1 Document control

Applicant reference number P00700

FRNSW reference number FRN23/3144

Premises name	Broadwater Public School
Primary street address	9 Byrnes Street

Figure 13: Indicative signage to double doors prohibiting the storage of flammable liquids or combustible goods in the undercroft storerooms.

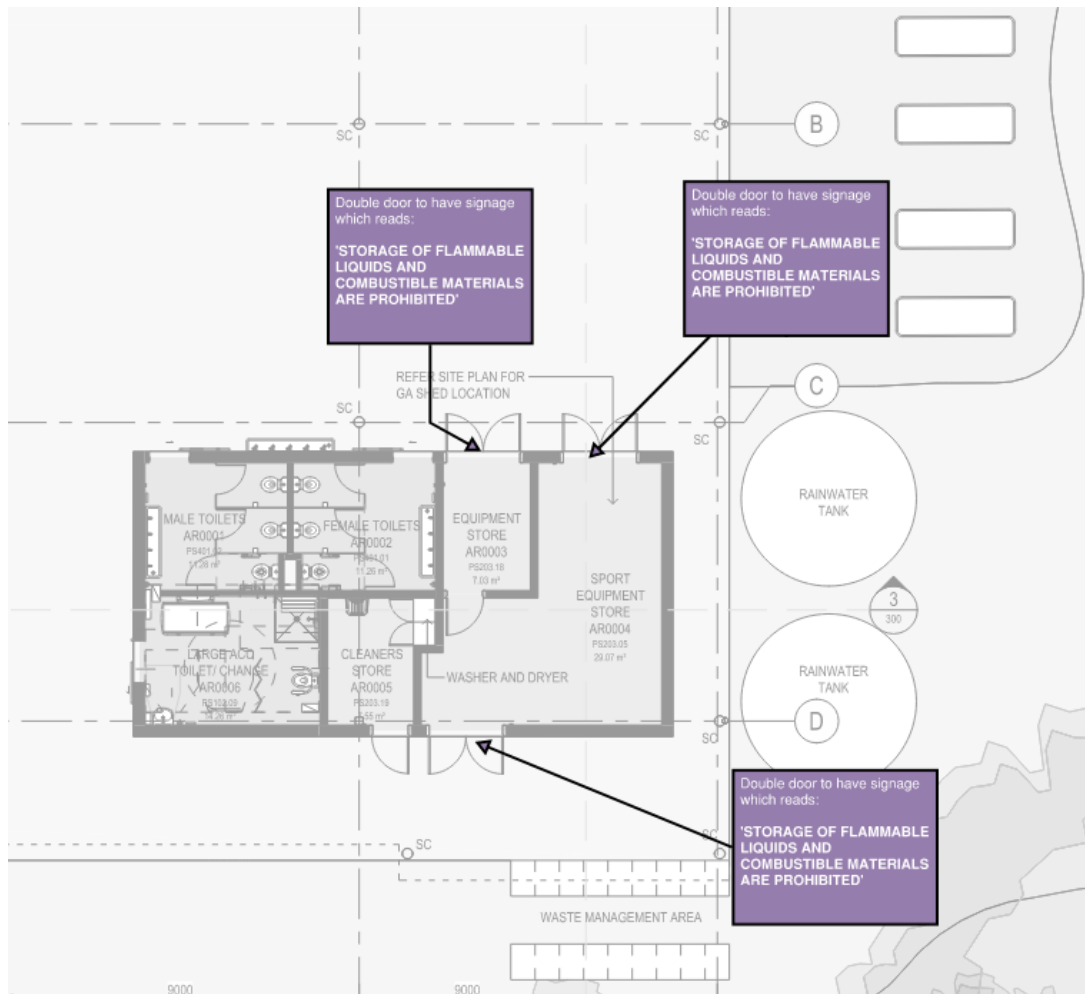
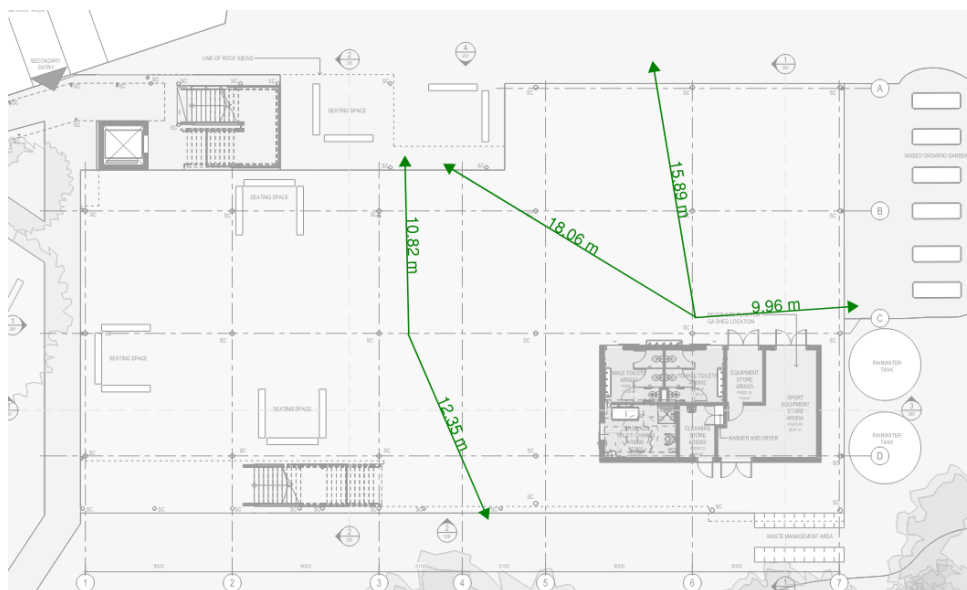
FRNSW Comment: FRNSW recommend management in use procedures be implemented to ensure the sterile requirements of the space are maintained accordingly.

E-LAB: Noted, see above.

Figure 29: Canteen walls to have PIR insulation.

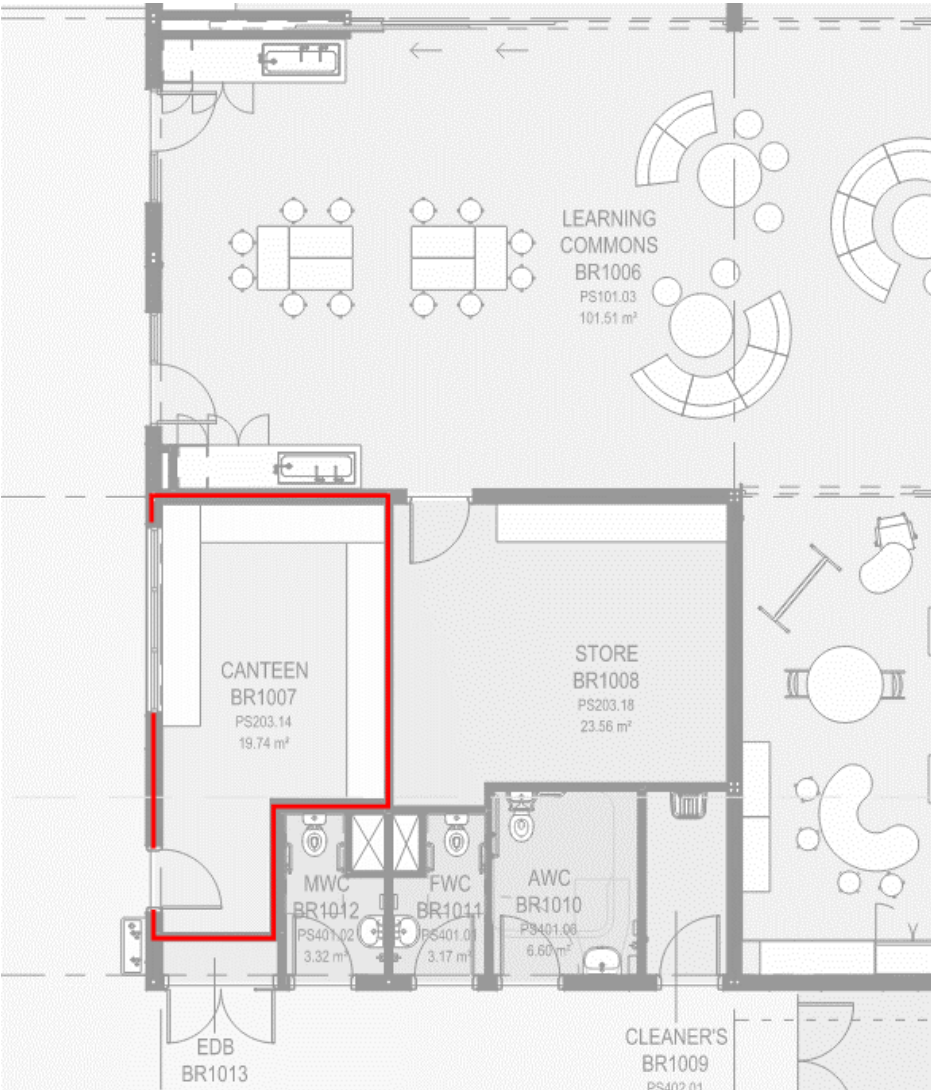
FRNSW comment: FRNSW recommend the extent of ISPs be clearly depicted to permit a considered review.

E-LAB: The PIR insulation is only to be installed in the walls of the canteen. All walls of the canteen shall possess the PIR insulation. The non-compliance strictly relates to the Type B construction requirements mandating all external wall to be constructed from non-combustible building elements. PIR while noted as being flame retardant does not meet the non-combustible requirements of the NCC.
